The Commission has issued the enclosed Amendments Nos. 52, 47 and 24 to Facility Licenses Nos. DPR-33, DPR-52 and DPR-68 for the Browns Ferry Nuclear Plant Units Nos. 1, 2 and 3. These amendments consist of changes to the Technical Specifications in response to your request of January 5, 1979 (TVA BFNP TS 119).

The amendments authorize you to substitute a computational thermal model for in-situ temperature monitoring stations to determine compliance with the mixing zone temperature limits and the State of Alabama water temperature standards.

BROWNS FERRY NUCLEAR PLANT, UNIT NO. 1

AMENDMENT TO FACILITY OPERATING LICENSE

Figure 2.1-1
Location of Water Temperature Monitors in Wheeler Reservoir
Browns Ferry Nuclear Plant

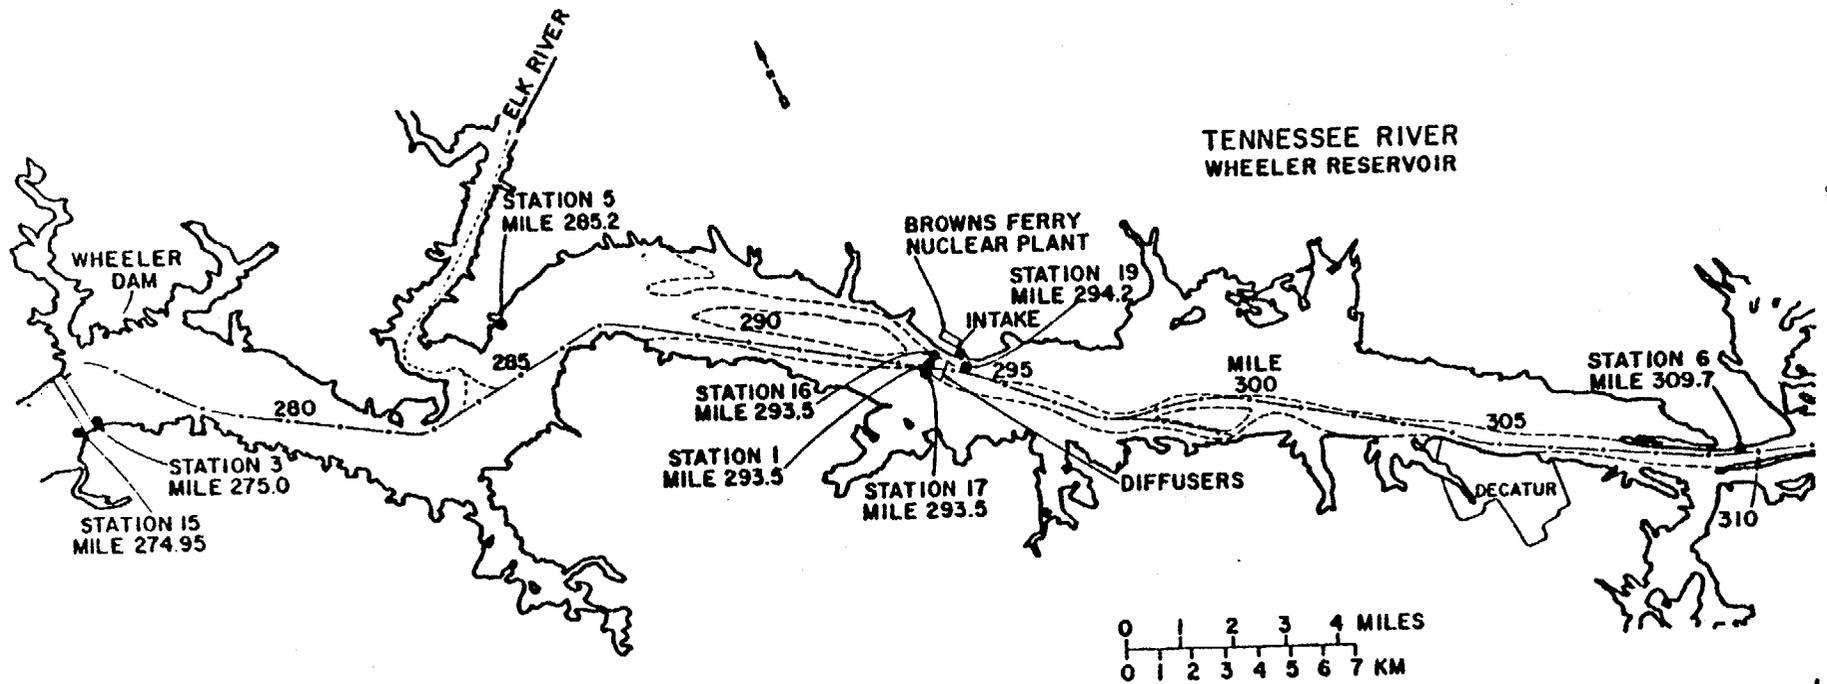
Reservoir water temperatures used to help show compliance with applicable standards will be measured at the one-meter and two-meter depths and averaged to give a temperature applicable to the five-foot depth, which is the point of application of the current Alabama temperature standards. Three thermal monitors spaced across the reservoir in the vicinity of river mile 293.5 shall be used to measure downstream mixed water temperatures. The system is designed so that the downstream monitors serve as backup for one another. The accuracy of the monitoring equipment and the sensitivity of the thermistor sensors are designed to be ±0.3°F and 0.01°F, respectively. The locations of temperature monitors are displayed in Figure 2.1-1.

The plant-induced temperature rise shall be computed using a computer model for the mixing of the plant discharge. This model requires measured plant data as well as downstream reservoir temperatures as inputs and will be updated as necessary to reflect current understanding of discharge mixing predictions.

Figure 2.1-1
Location of Water Temperature Monitors in Wheeler Reservoir
Browns Ferry Nuclear Plant

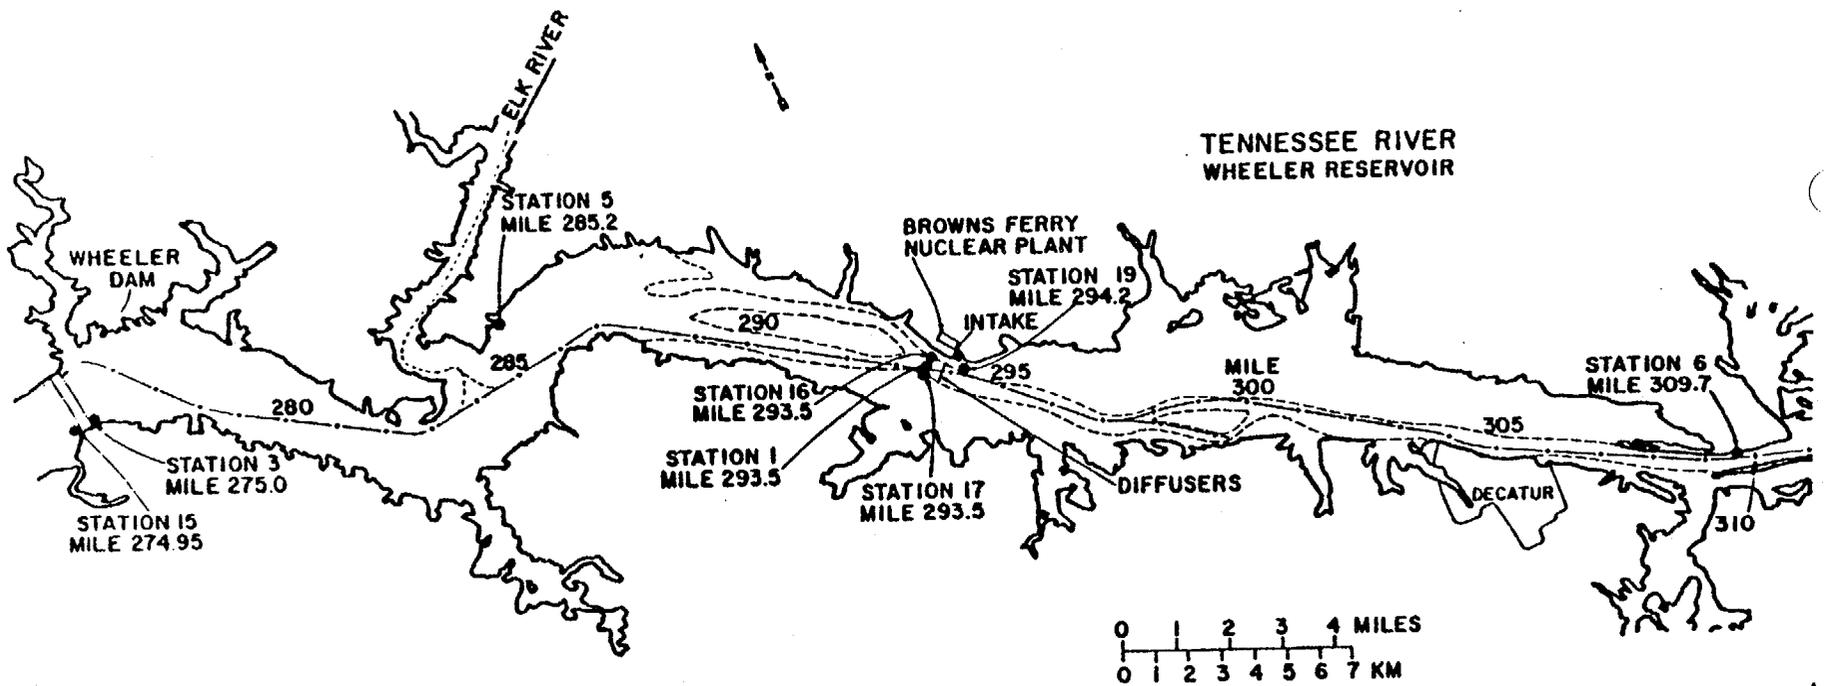
Reservoir water temperatures used to help show compliance with applicable standards will be measured at the one-meter and two-meter depths and averaged to give a temperature applicable to the five-foot depth, which is the point of application of the current Alabama temperature standards. Three thermal monitors spaced across the reservoir in the vicinity of river mile 293.5 shall be used to measure downstream mixed water temperatures. The system is designed so that the downstream monitors serve as backup for one another. The accuracy of the monitoring equipment and the sensitivity of the thermistor sensors are designed to be ±0.3°F and 0.01°F, respectively. The locations of temperature monitors are displayed in Figure 2.1-1.

The plant-induced temperature rise shall be computed using a computer model for the mixing of the plant discharge. This model requires measured plant data as well as downstream reservoir temperatures as inputs and will be updated as necessary to reflect current understanding of discharge mixing predictions.

Figure 2.1-1
Location of Water Temperature Monitors in Wheeler Reservoir
Browns Ferry Nuclear Plant

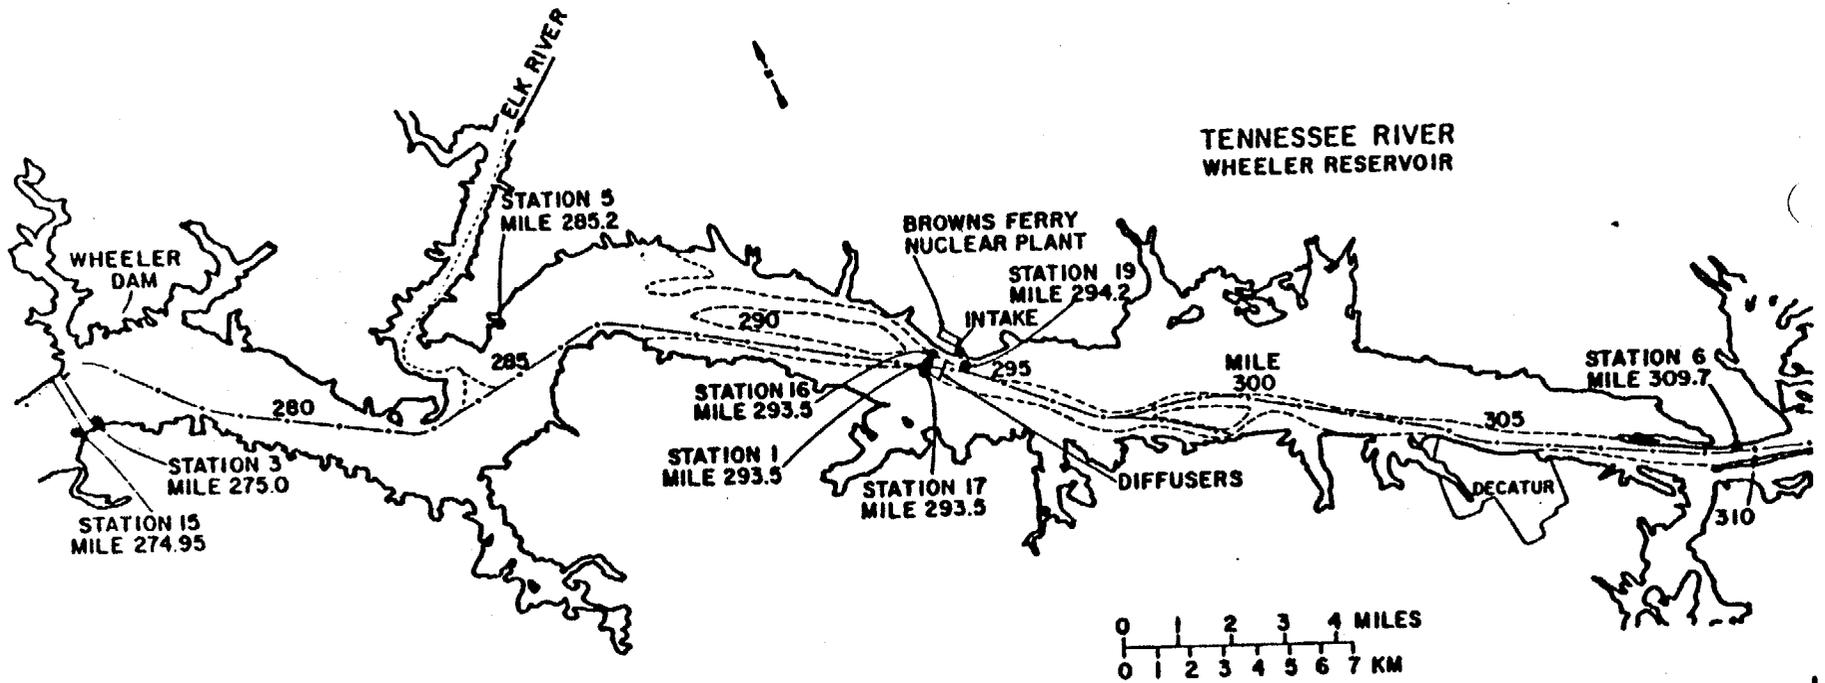
Reservoir water temperatures used to help show compliance with applicable standards will be measured at the one-meter and two-meter depths and averaged to give a temperature applicable to the five-foot depth, which is the point of application of the current Alabama temperature standards. Three thermal monitors spaced across the reservoir in the vicinity of river mile 293.5 shall be used to measure downstream mixed water temperatures. The system is designed so that the downstream monitors serve as backup for one another. The accuracy of the monitoring equipment and the sensitivity of the thermistor sensors are designed to be ±0.3°F and 0.01°F, respectively. The locations of temperature monitors are displayed in Figure 2.1-1.

The plant-induced temperature rise shall be computed using a computer model for the mixing of the plant discharge. This model requires measured plant data as well as downstream reservoir temperatures as inputs and will be updated as necessary to reflect current understanding of discharge mixing predictions.
